YI SUBDIVISION 1126 EDWARDS LANE

SUMMARY

PROPOSED PLAT

Map of Boundary & Topographic Survey

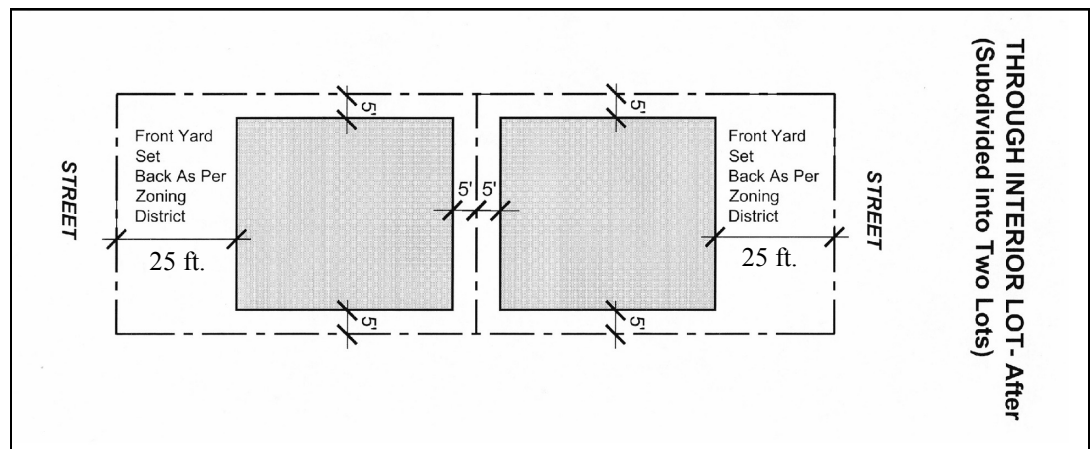
1. Sheet: (Survey) Needs to have a raised seal.FAC 5J-17.051 14) b.
2. The Map of Boundary & Topographic Survey submitted doesn't scale 1"=30'
3. Sheet: (Survey) The south remainder dimensions of lot 18 are missing.FAC 5J-17.052 7).

4. Sheet: (Survey) Edwards Lane and Latta Lane need the R/W, shown and located per plat.FAC 5J-17.052(d) 2.
5. Sheet: (Plat) The sheet number and total number of sheets are missing. FS 177.091 (3)

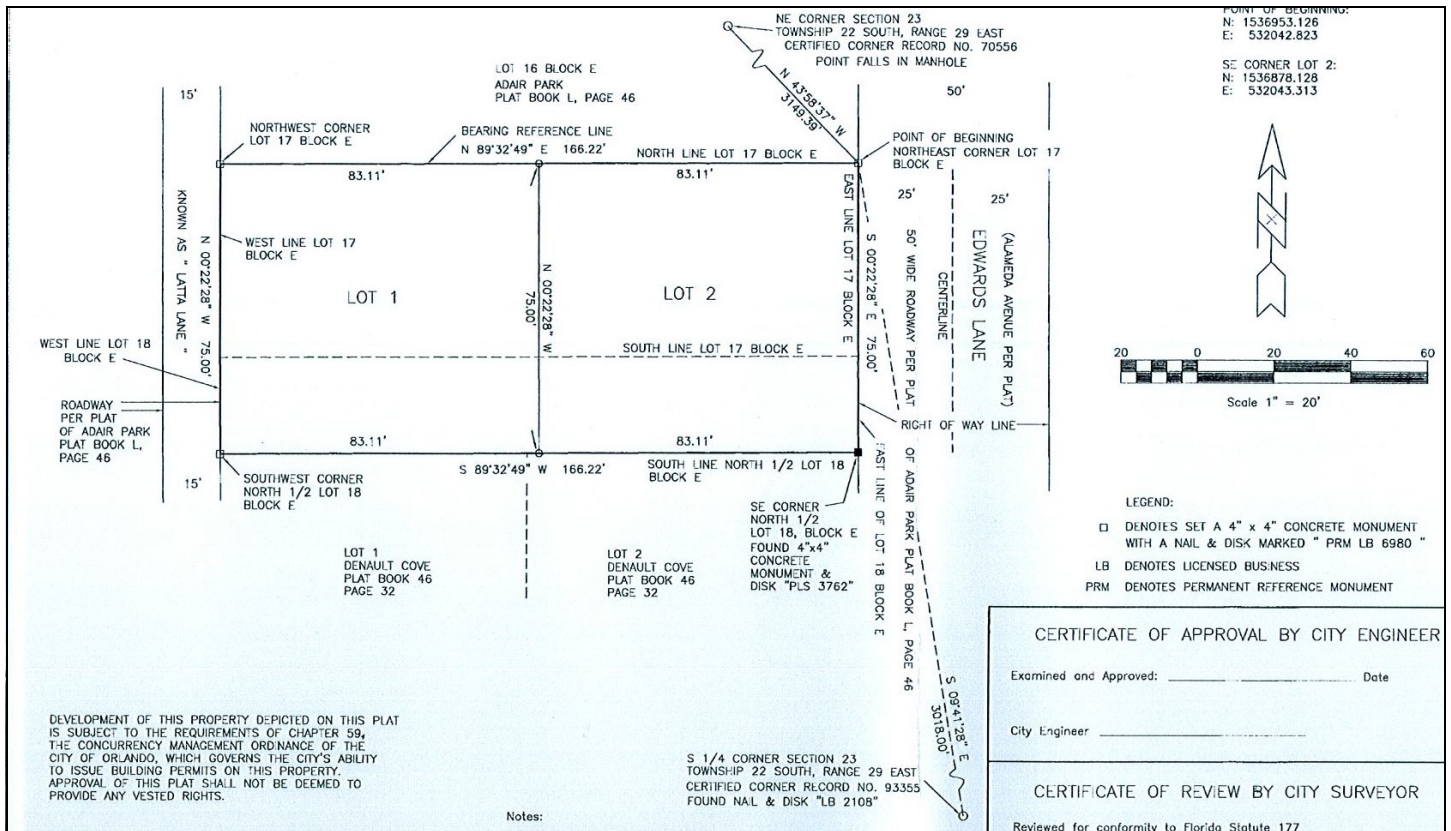
6. Sheet: (Plat) Latta Lane R/W width needs to be corrected. FS 177.091(15)
7. Sheet: (Plat) if there aren't any dedications being made by the plat add the statement and hereby dedicates nothing to the public or something to that affect.

8. Sheet: (Plat) The legend doesn't show what the circles are at the lot split of 1 & 2.
9. Field Review has not been completed at this time. Email Dean Hill and copy me to schedule future field checks. Dean can be reached at dean.hill@cityoforlando.net. FS 177.091(7)
